Access Compliance Report

Public Rights-of-Way

(Curb Ramps)

| Intersection ID: 13143 | Main Street: OSMOND_ST | Cross Street: BETHEL_RD | Location: NE |

| ADA ID: A8D670EC58BA | Ramp Type: BlendTrans2 | Initial Pass/Fail: Fail | Overall Compliance: No |

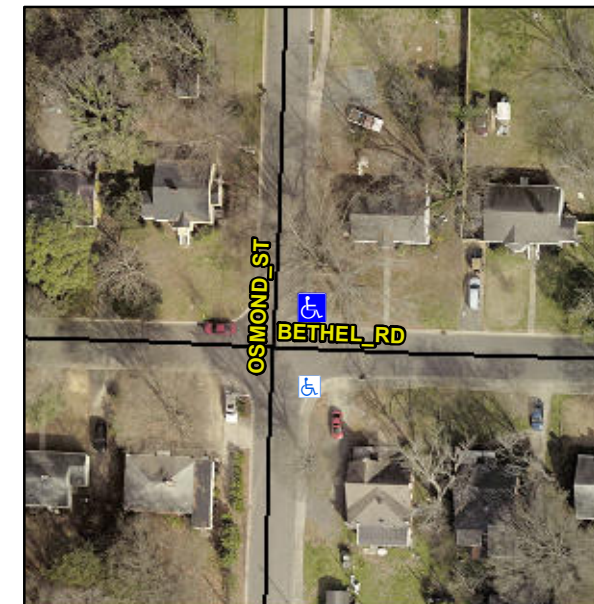
Not Found, R304.5.1, R304.5.3

| Compliance | Description | Data | Compliance | Description | Data |
|------------|-----------------------|------|------------|-----------------------------|------|
| No | Ramp Width (in) | 39.0 | No | BlendTrans XSlope (%) | 2.9 |
| | | | No | Curb Slope (%) | 16.7 |

Remove & Replace Curb Ramp With Two New Directional Ramps or Equivalent.
